**TOWN OF BAY HARBOR ISLANDS
MORRIS N. BROAD COMMUNITY CENTER
1175 95TH STREET
BAY HARBOR ISLANDS, FL 33154**

DEVELOPMENT & REVIEW COMMITTEE MEETING

**TOWN OF BAY HARBOR ISLANDS
COMMUNITY DEVELOPMENT
MEMORANDUM**

Subject: Site Development Plan Application
9761 West Bay Harbor Drive– 6 DU Townhouse Complex
Bay Harbor Luxury Townhomes
Bay Harbor Islands Acct. No. SPR2024-000021
MMPA Acct. No. 01-0702-1196

SITE PLAN

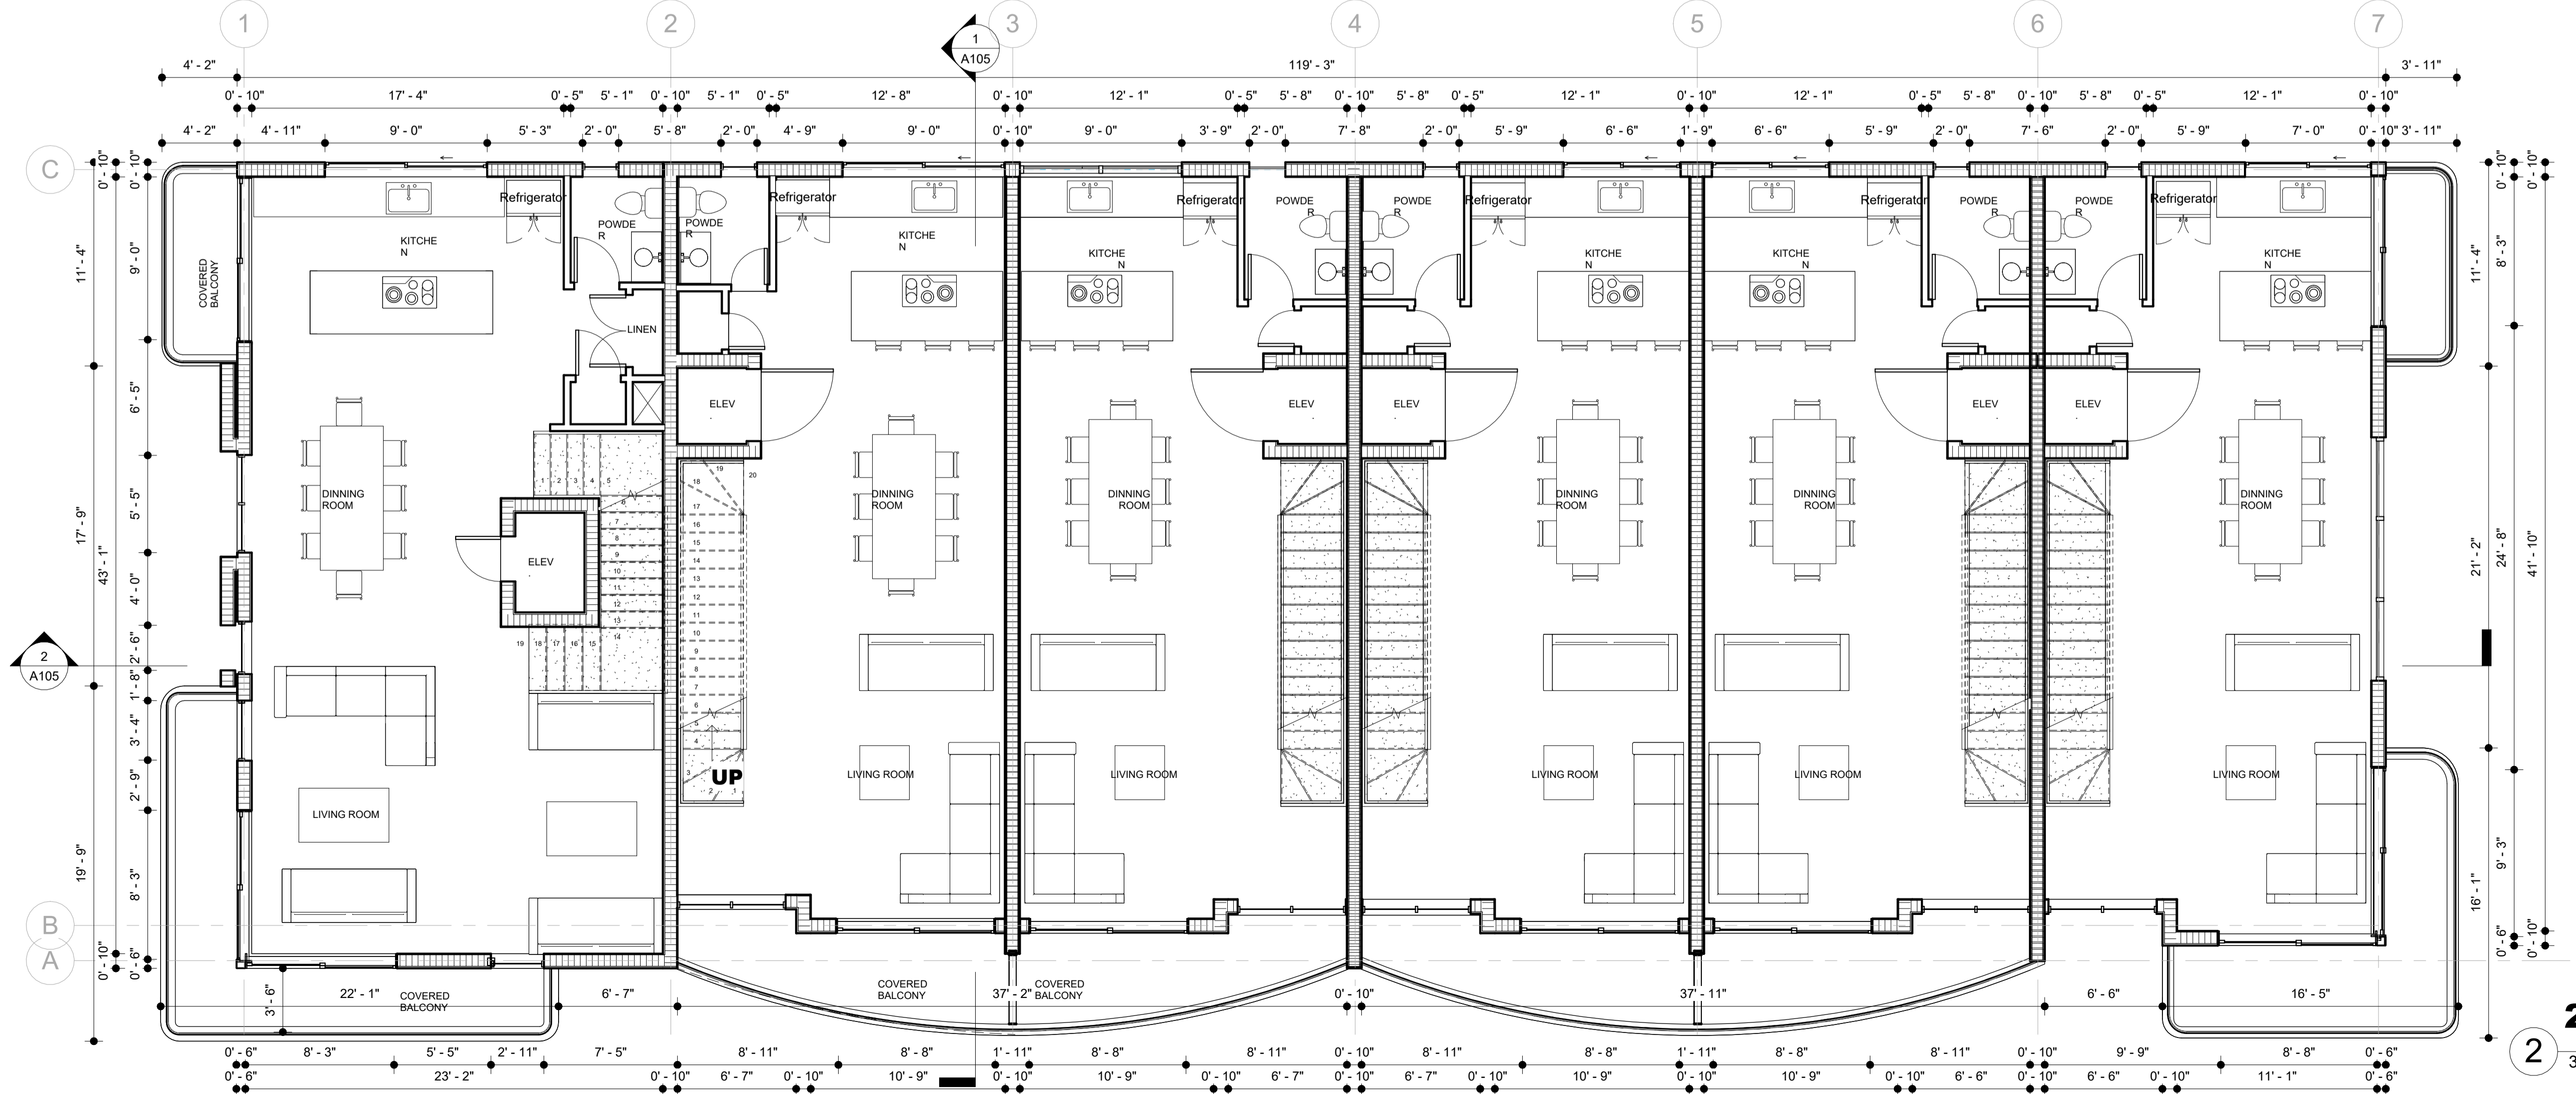
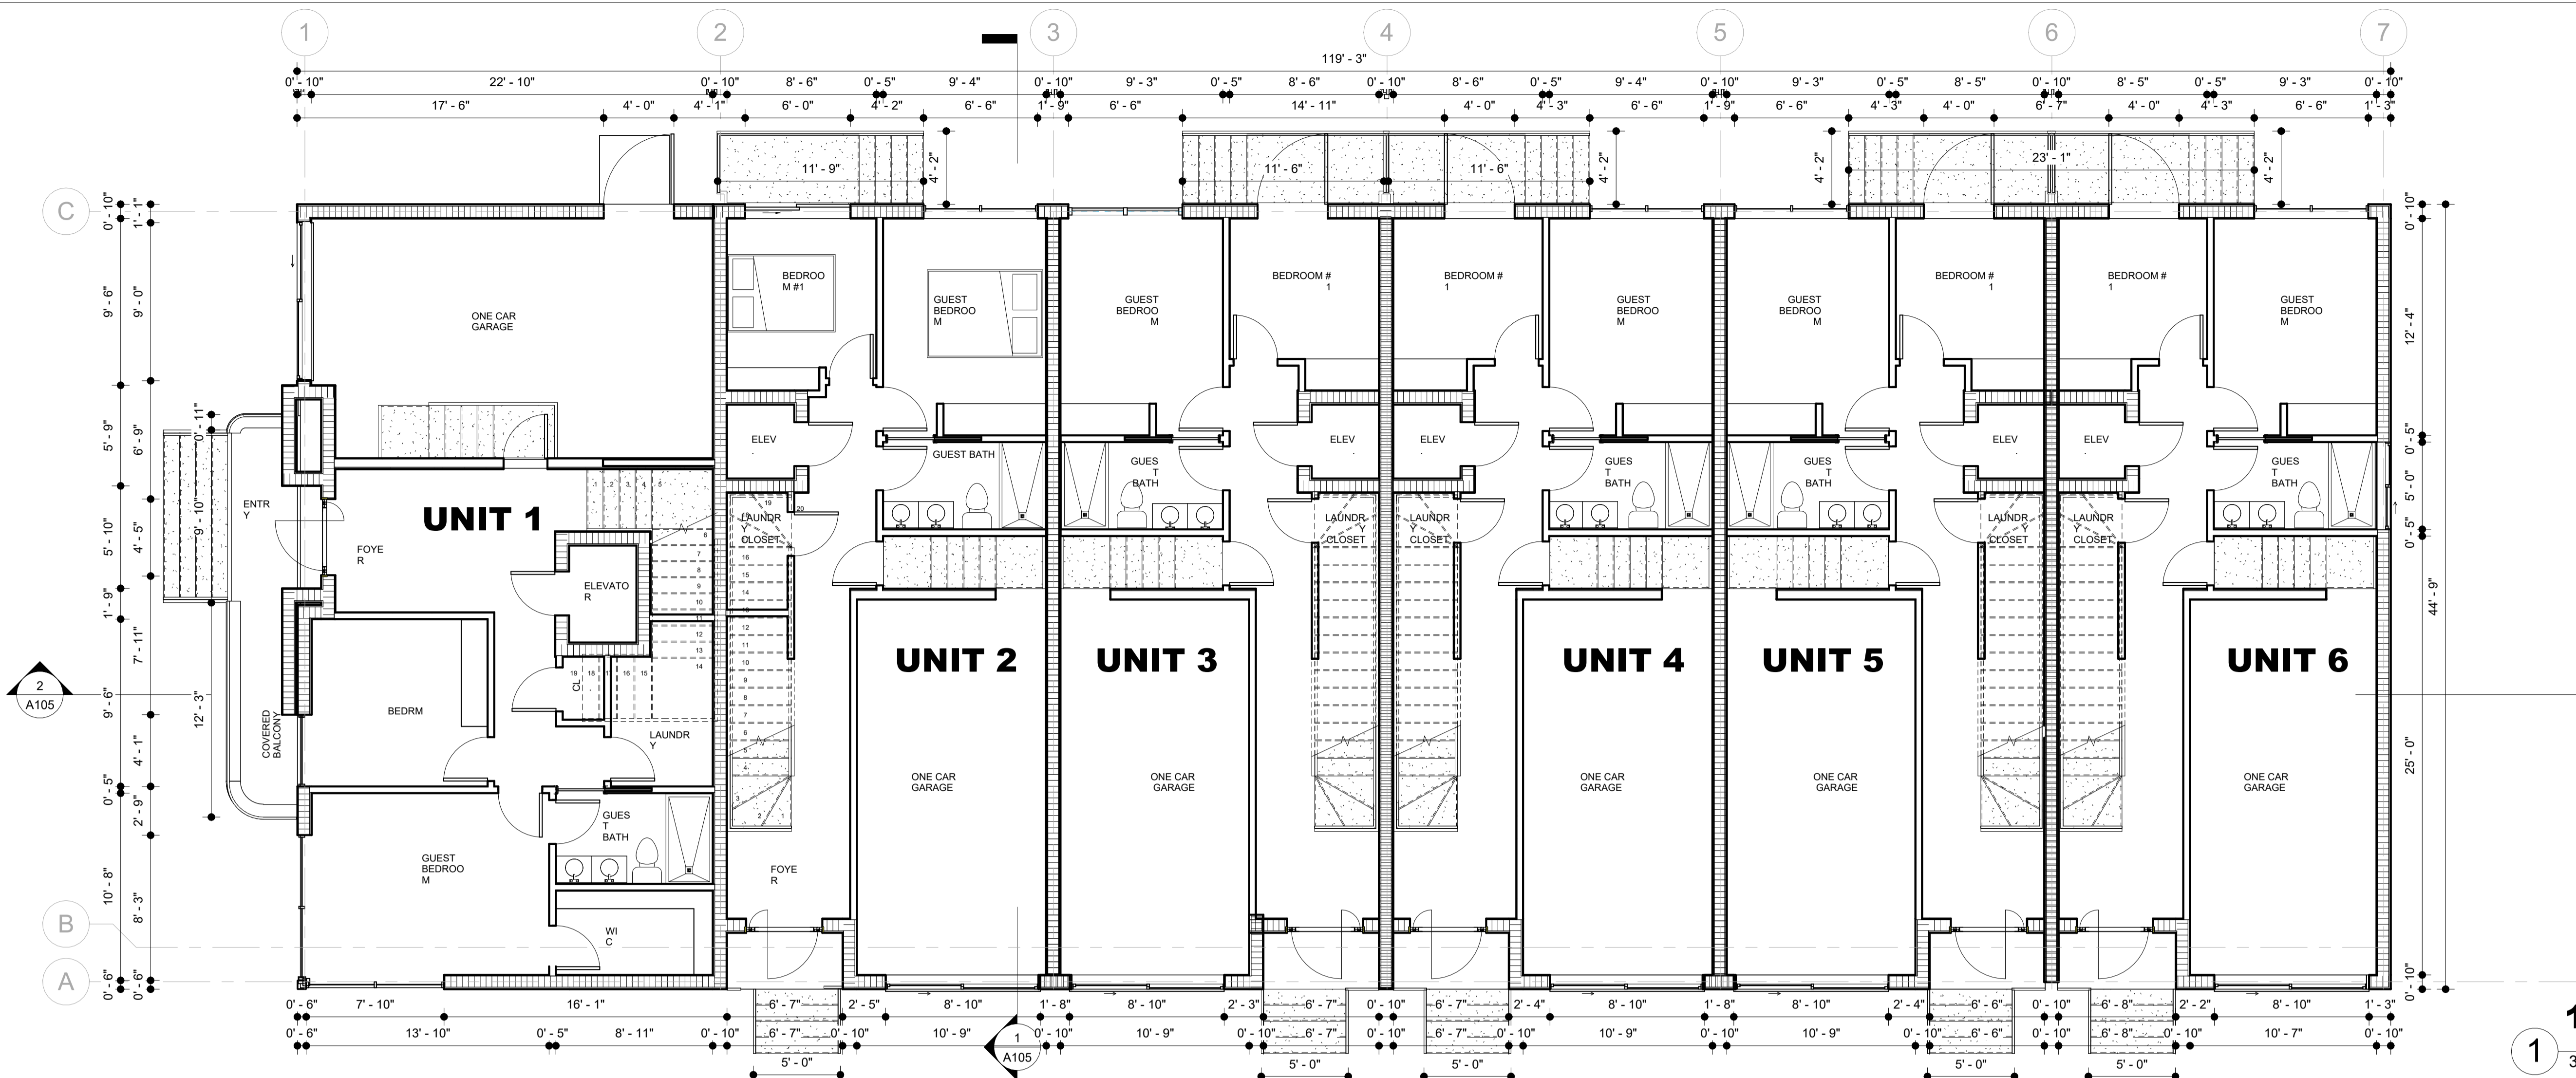
- 1) The General Code Data table on Sheet A-100 has the following issues:
 - a. The FLUM designation of Medium-High Density (6-34 DUA) must be listed.
- 2) The Setbacks and Height Requirements table has the following issues:

- a. The maximum height allowed should state 65'-0" above BFE + 1' FBC Freeboard.
 - b. The height provided is 37'-10" above BFE to the main roof deck, although there are portions of the building that exceed that (access elevator / stairs) (47'-10").

- 7) The Site Plan has the following issues:
 - a. The Site Plan shows proposed fences. Please provide a detail of the proposed fences along the property lines.

- b. Provide a detail / plan showing pervious and impervious areas for project.
- c. Please shown the elevation of the proposed garage and habitable ground floor. Per Sec. 5-17 of the Town Code, enclosed garages must be at least 18" above grade. Habitable areas must meet FEMA and FBC requirements (currently 9' NGVD). Update the General Code Data table accordingly.
- d. The building setbacks are not correct. Per Sec. 23-11(B2) (1)(2)(3) the proposed building is over 30' in height; therefore, additional setbacks are required for those portions of the building exceeding 30'.

Summary - The front setback shown on the plans along West Bay Harbor Drive and 98th Street is shown as 20', which would be acceptable for those portions of the building under 30 feet in height. For those portions of the building over 30' in height the building must step back to 25' (except Flex areas). As to the side and rear setbacks, for those portions of the building over 30' in height the building must step back an additional 1' for each 3' of building height (except Flex areas).

- e. The off-street parking arrangement is not acceptable and does not meet Code. As mentioned above, Section 23-24(d)(5)(c) of the Town's Code states that for townhouse projects at least one (1) space must be in a garage and other parking spaces must be accessible without driving over or through another parking space. As designed each DU has one internal parking space in a garage, but the 2nd parking space is shown on the single driveway adjacent to the garage and one must drive over that space to the street (not allowed).

- f. The driveway material must be a solid surface all the way across (not just strips for the tires). Per Sec. 23-24(d)(6), in townhouse developments where units have a direct driveway connection to the street, the driveway connections are limited to a maximum width of 12 feet for a single driveway and 18 feet for a double driveway at the curb line. Individual driveways must be separated by landscaped islands of at least two (2) feet in width and designed to include privacy walls or fences, shrubs and small trees/palm species to avoid a continuous hardscape appearance, and to provide privacy between individual units. Not more than 50 percent of a property street frontage may have hard driveway surfaces (would meet this criteria). Additionally, while two parking spaces appear to be provided for each unit, each parking space must be accessible without driving over or through another parking space. As designed the parking garage space cannot back over the outdoor space.

- g. Provide the location and type of mail receptacles.
 - h. Unit #1 shows a sidewalk with a width that scale about 10'. Per Sec. 23-12(15) the max. allowable width of a sidewalk is 5'. Please revise and dimension. Sidewalks in front of the units 2-6 are also not dimensioned. Please dimension the sidewalks.

- 11) The site plan appears to have a lot area of 11,116 square feet. The Miami- Dade Property Appraiser has the lot area of 11,250 square feet. The survey does not provide a lot area. Up-date the survey with lot area. How was the 11,116 sq. ft. derived?
